Commonwealth Edison Company

Subject: Additional Information to Final Report
of Safety Valve Operation following a
Feedwater Transient - Dresden Unit 3
(DPR-25)

ENCLOSURE

DRESDEN STATION, UNIT 3
REACTOR FEEDWATER PUMP
HIGH REACTOR WATER LEVEL TRIP
PRELIMINARY DESIGN

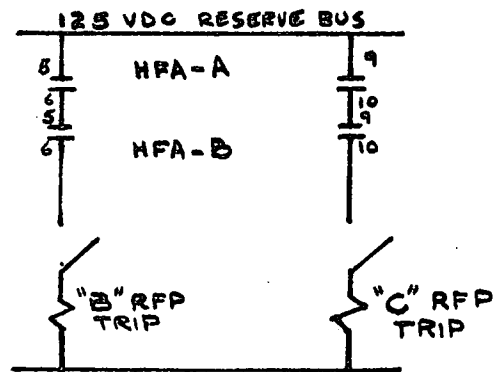
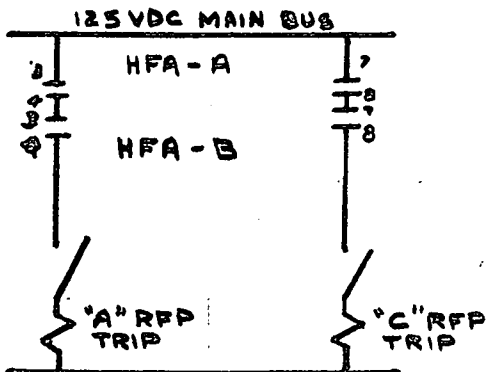
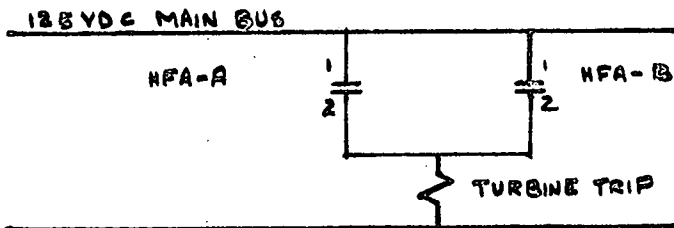
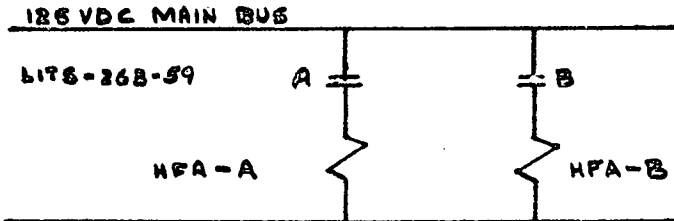
- a. What is the current status of your evaluation?
- b. Provide the proposed details of the reactor feedwater pump high reactor water level trip and the bases for selecting the trip water level.

- b. The reactor feed pump trip initiation signal is taken from the turbine trip contacts set at reactor water level 48 inches. Through appropriate relaying, the pumps will be tripped by a

two out of two logic circuit (an electrical schematic is attached). The level set point was selected the same as the turbine trip and high level isolation, because isolation and turbine trip eliminate major loss of primary system water inventory and the need for feedwater. This level setpoint was also selected to terminate a high level transient before water reached the HPCI, isolation condenser or main steam nozzles.
